**CITY OF AUSTIN –DEVELOPMENT SERVICES DEPARTMENT
SUBDIVISION APPLICATION – MASTER COMMENT REPORT**

CASE NUMBER: C8-2022-0330
UPDATE: U0
CASE MANAGER: Juan Enriquez, Senior Planner juan.enriquez@austintexas.gov

PROJECT NAME: Harris Branch Commerce Park(W/R C8-2020-0186)
LOCATION: 6400 E PARMER LN

SUBMITTAL DATE: January 23, 2023
FINAL REPORT DATE: February 16, 2023

HARRIS BRANCH COMMERCE PARK
PROPOSED WETLANDS & SETBACKS

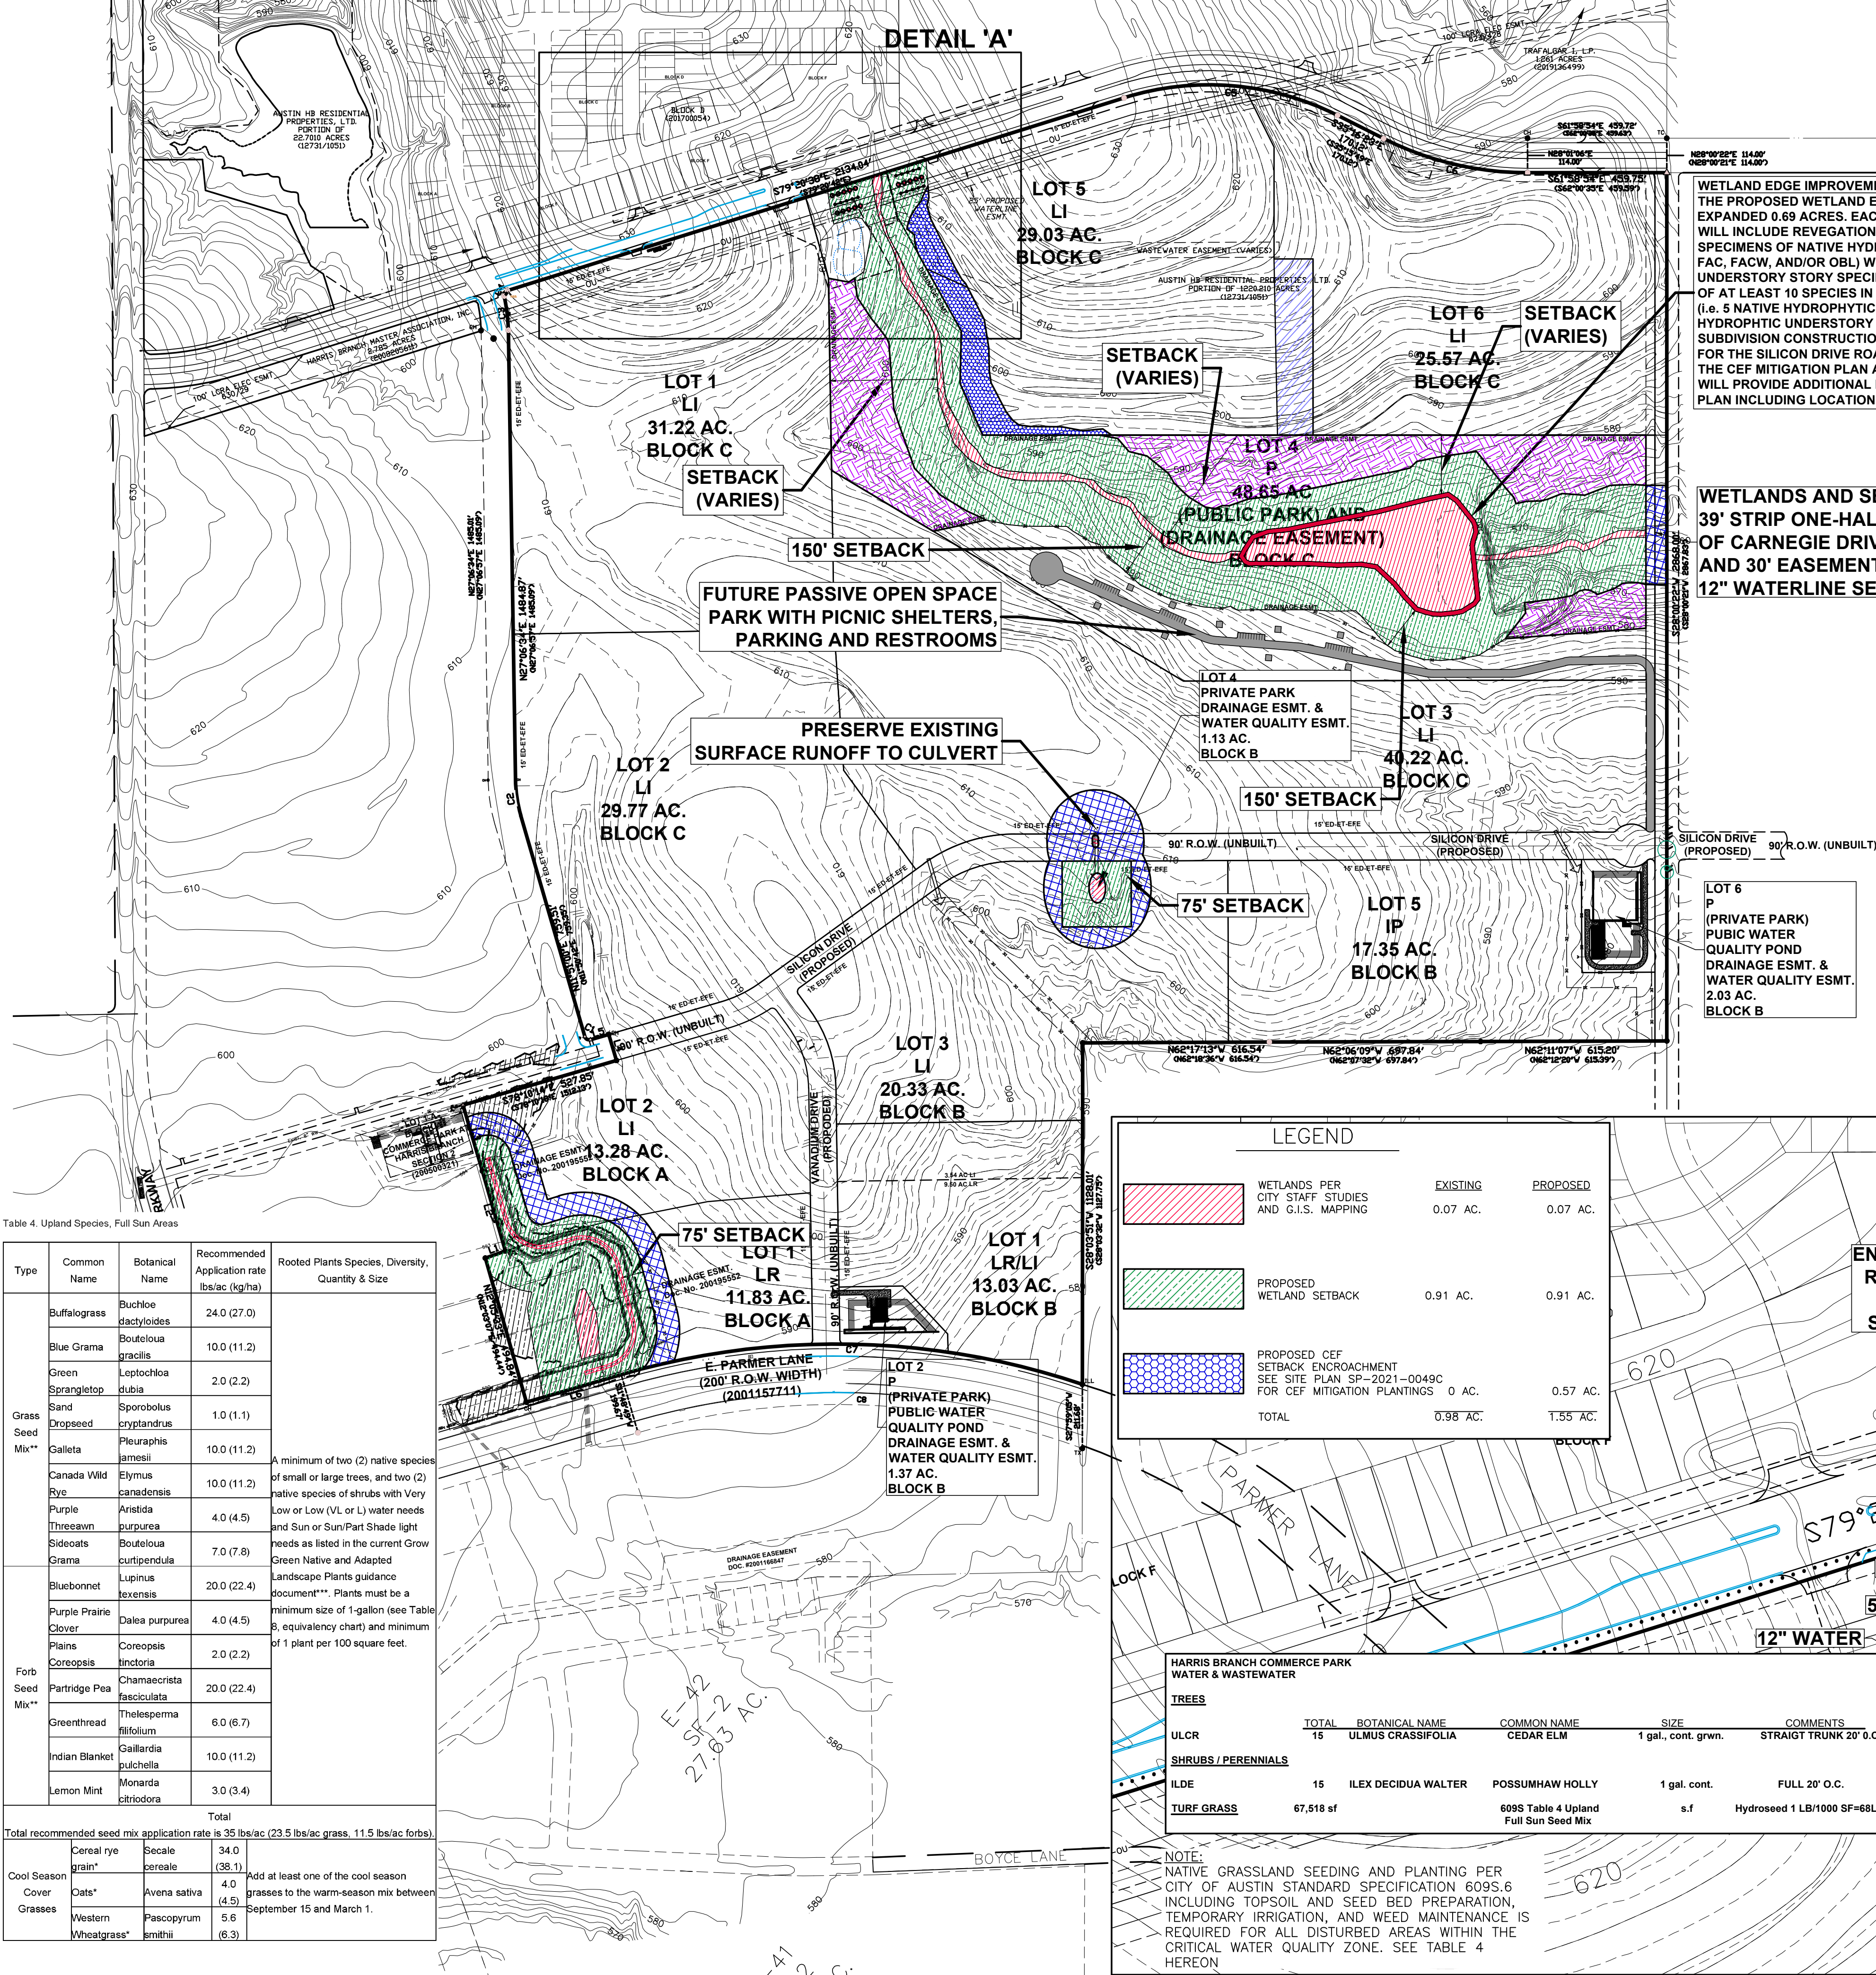
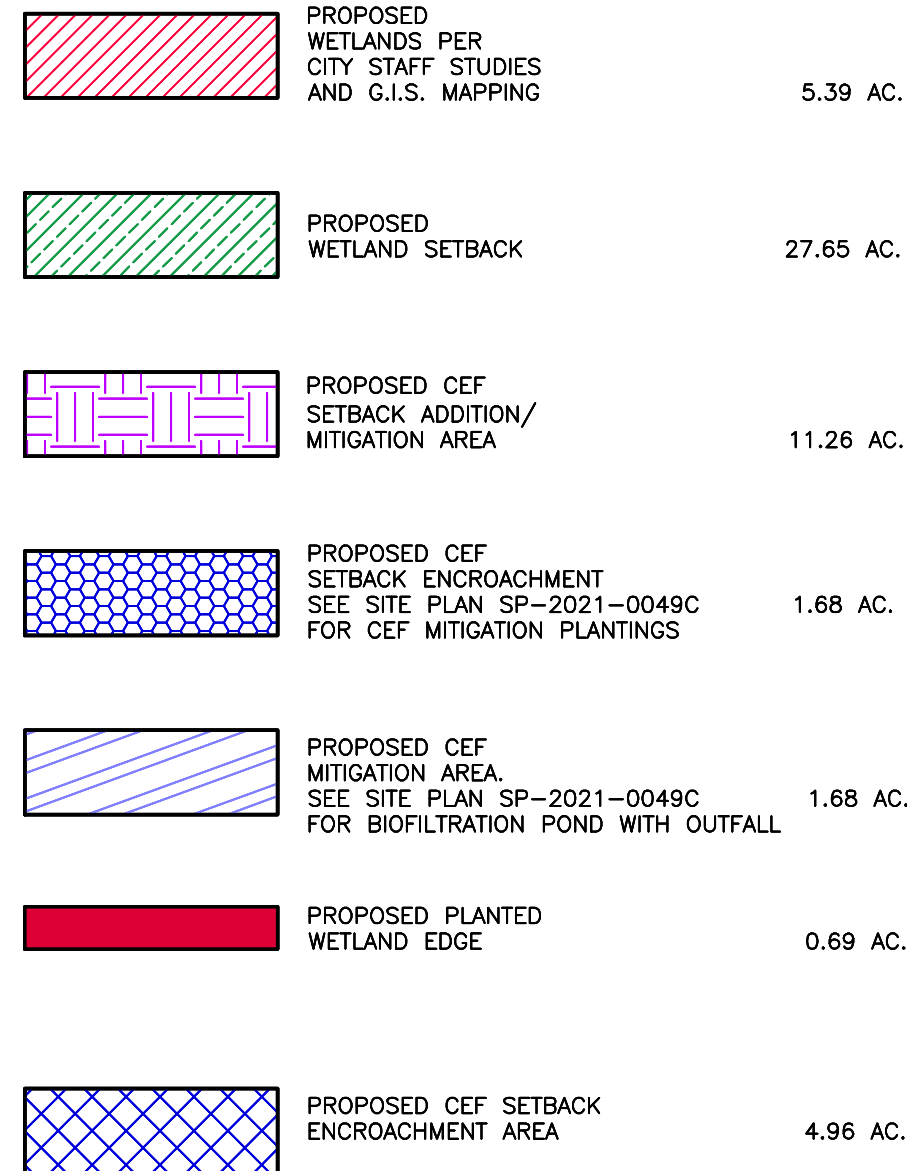
Additional information: {*This comment can be addressed by clearly showing and labeling "WETLAND CEF SETBACK" on all plan sheets where the CEFs and CEF setback are contained within the area shown. Use the CEF setbacks as they are proposed and shown on exhibit H.*}

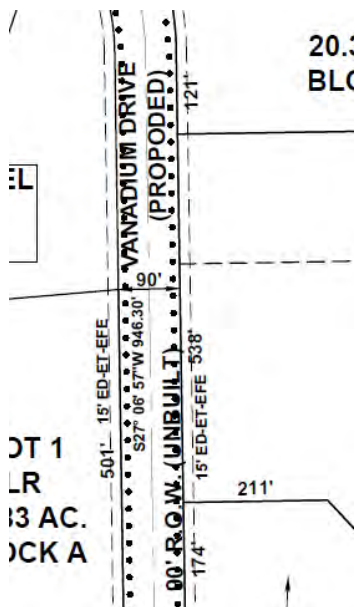
NOTE: Addressing recommends to please place callout labels directly on the ROW and not on a parcel

NOTE: The word "Proposed" is misspelled and can be removed. The additional labels "proposed" and "existing" are used to distinguish built from unbuilt ROW's when both built and unbuilt sections are displayed on major roads
